Department of Energy

RESPONSE TO THE U.S. ENVIRONMENTAL PROTECTION AGENCY AND OHIO ENVIRONMENTAL PROTECTION AGENCY COMMENTS ON SILO 3 PROJECT REMEDIAL DESIGN PACKAGE

ENCLOSURE: DRAFT RESPONSES TO U.S. EPA GENERAL COMMENTS ON
SILO 3 REMEDIAL DESIGN PACKAGE

SILO 3 PROJECT
FEMP
FIRE WATER & PLANT WATER
P&ID

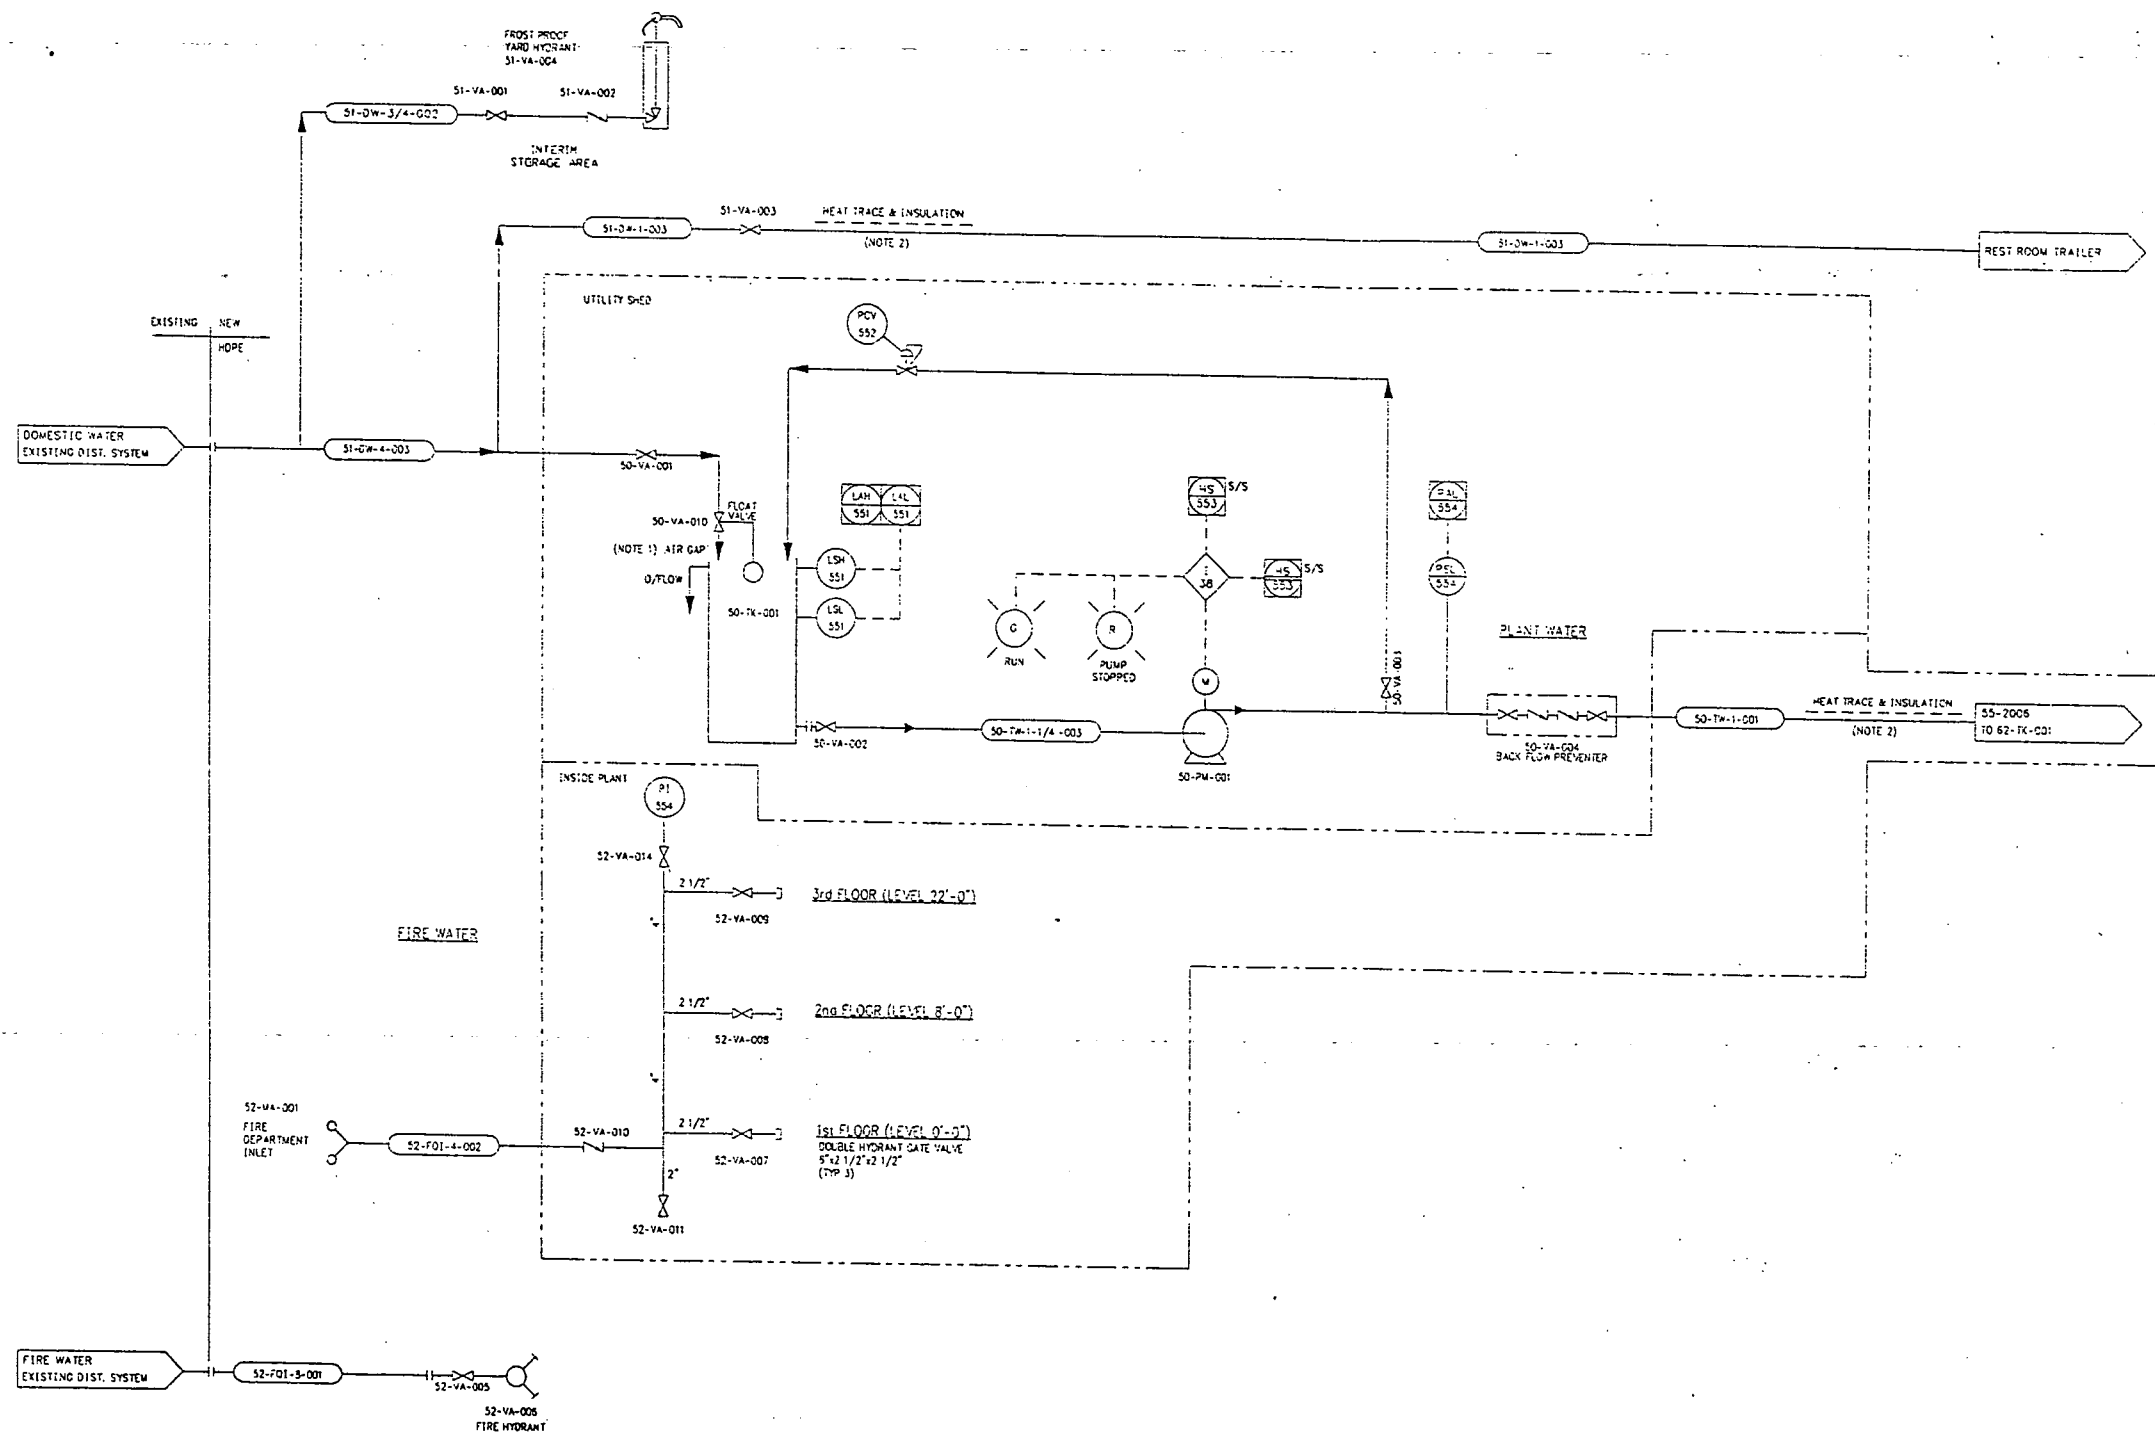
Comment: The text states that the plant water system is shown on P&ID No. 55-2019; however, this drawing is missing from the submittal. The plant water system cannot be reviewed without this P&ID. The resubmittal should include the required drawing for review.

Response: P&ID 55-2019 was inadvertently left out of the previous submittal and is now attached.

SILO 3 PROJECT
FEMPAIR UTILITIES
P&ID

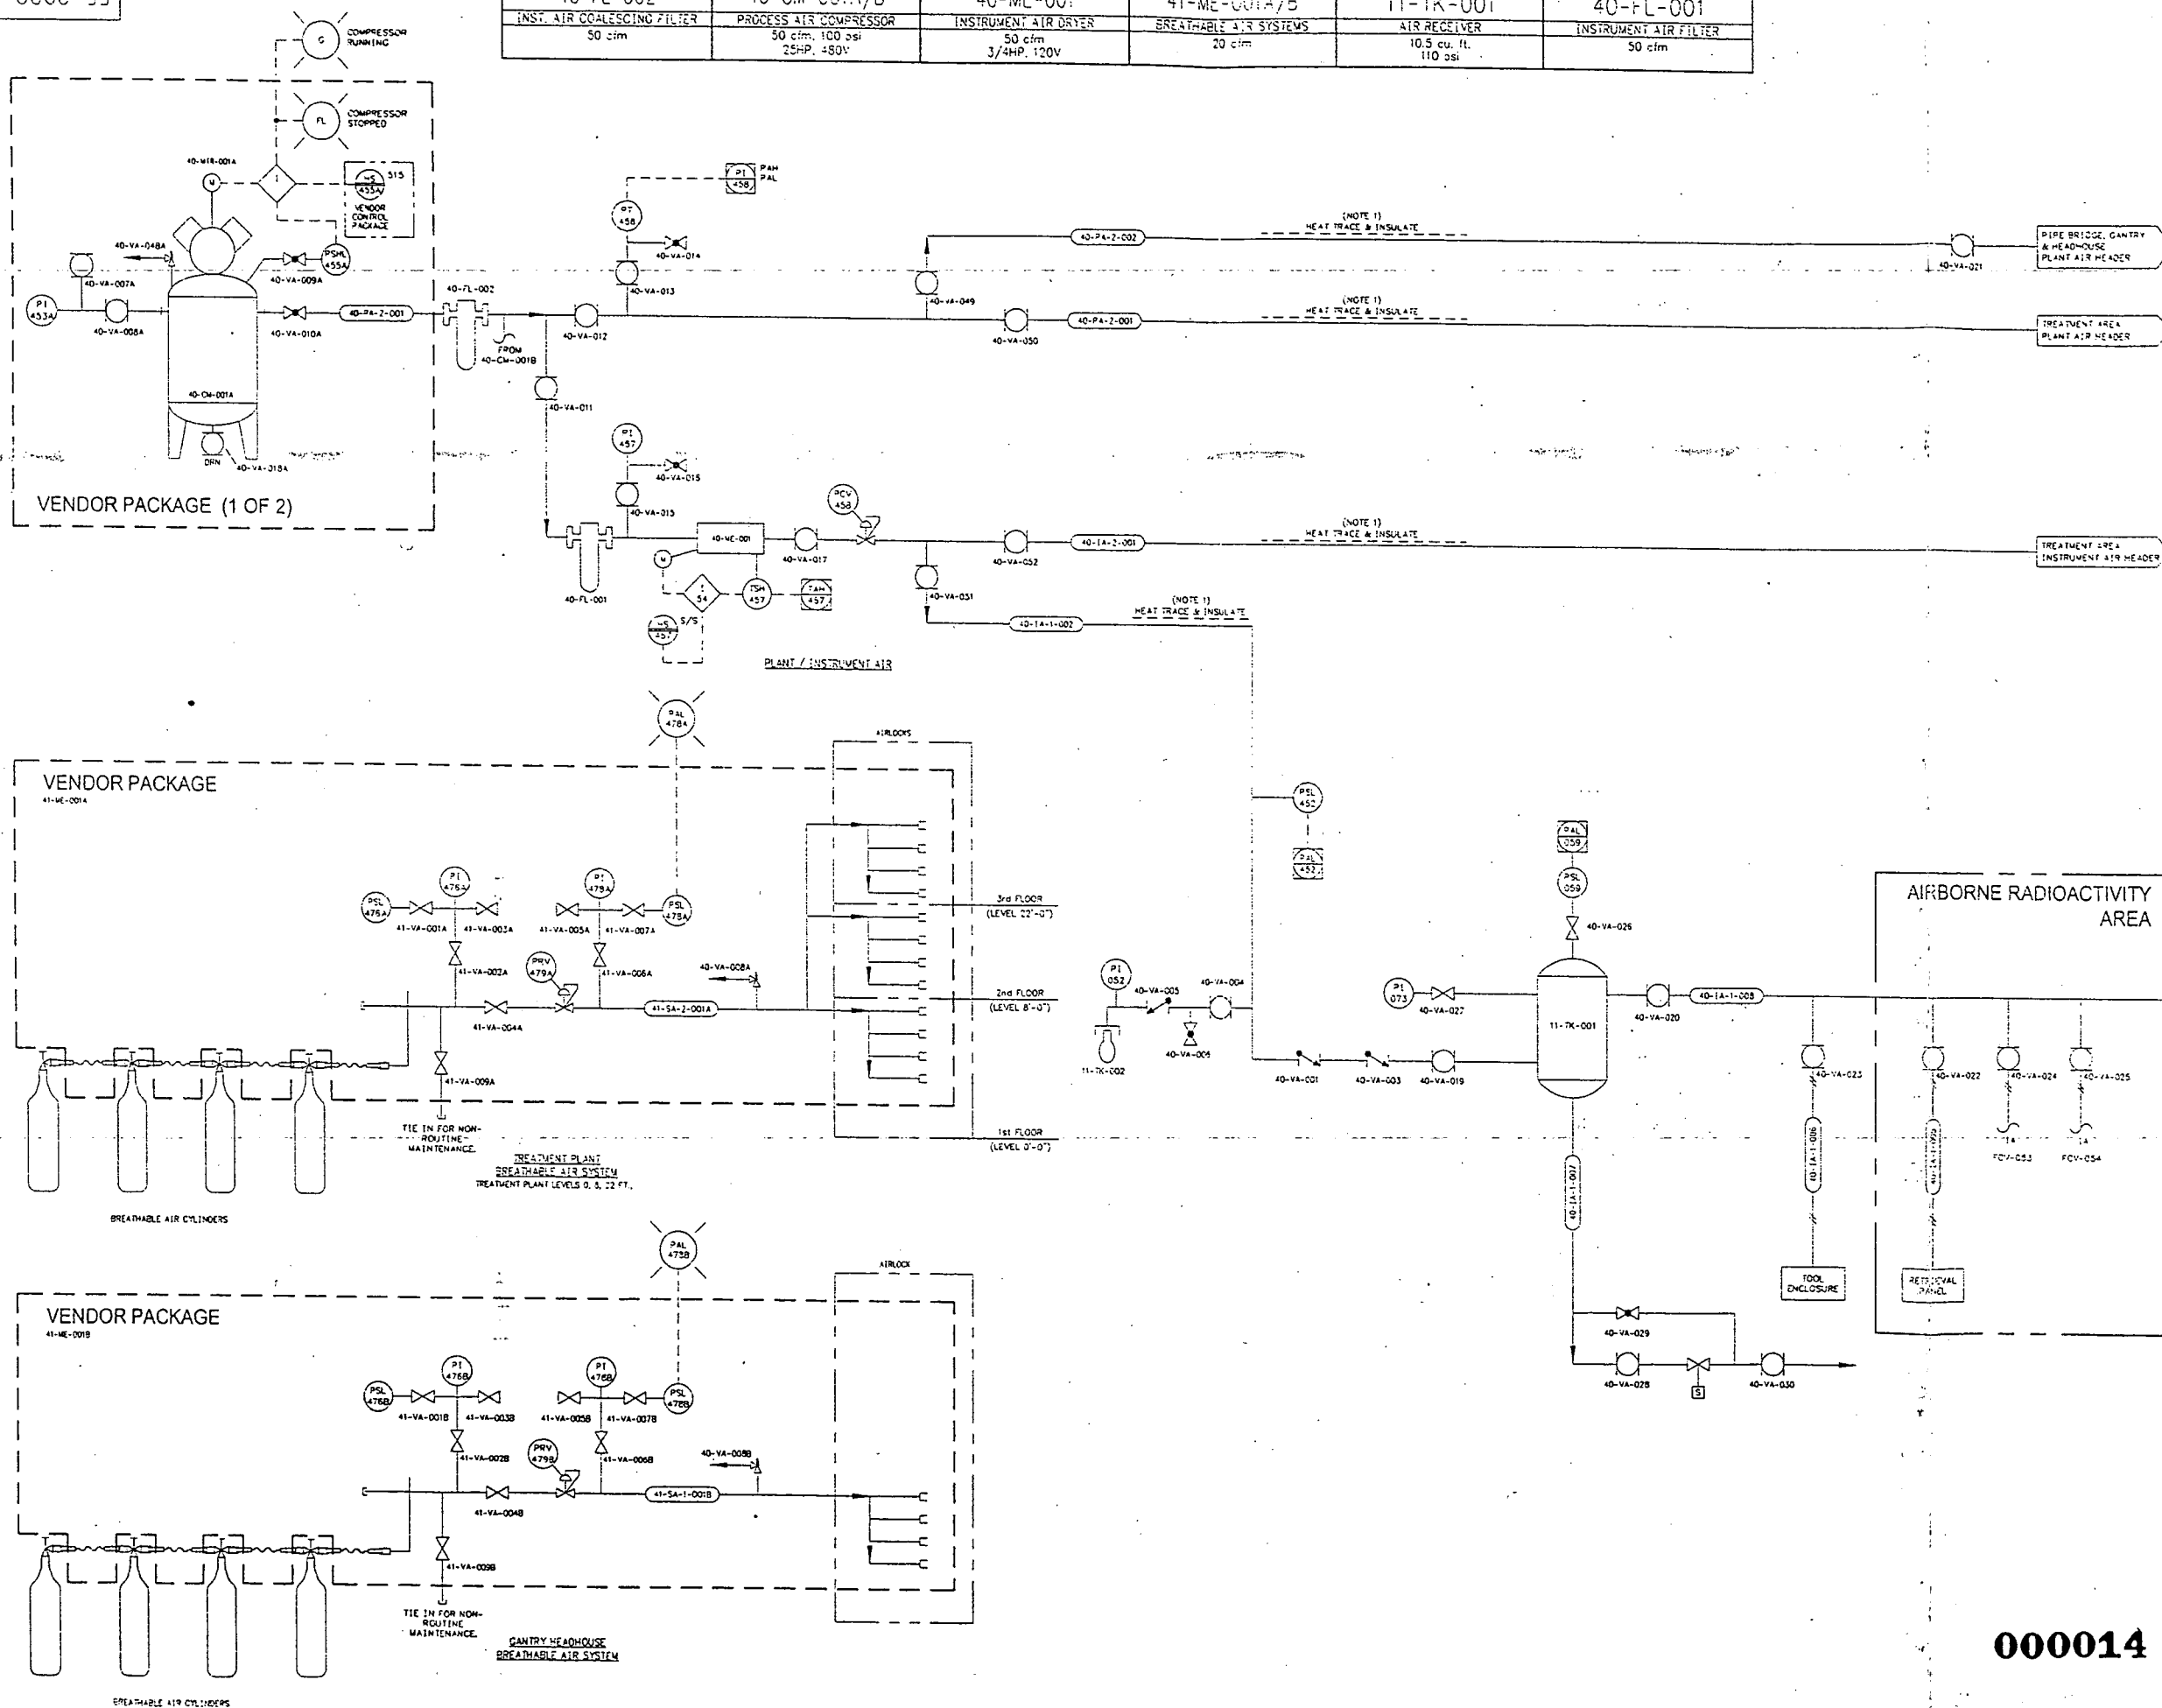
Comment: A number of valves, dampers, and other devices are shown as being pneumatically operated or controlled. The instrument air system to be used for this purpose will need to be monitored. The P&IDs, however, do not indicate how the instrument air system will be monitored and controlled. In the event that this system fails (that is, instrument air pressure drops), there should be an interlock from a pressure switch to initiate shutdown of all systems that use instrument air for operation or control purposes as well as all systems upstream. System shutdown can be done by the programmable logic controllers (PLC). The P&IDs should be reviewed to ensure that an interlock for emergency shutdown of these systems is included.

Comment: The text refers to P&ID No. 55-2020; however, this drawing is missing from the submittal. As a result, Section 3.8, Plant Air System, cannot be reviewed at this time. The resubmittal should include the required drawing for review.

Response: P&ID 55-2020 had been erroneously omitted and is now attached and shows the monitors, controls, and interlocks for the instrument air system.

Response: P&ID 55-2020 was inadvertently left out of the previous submittal and is now attached.
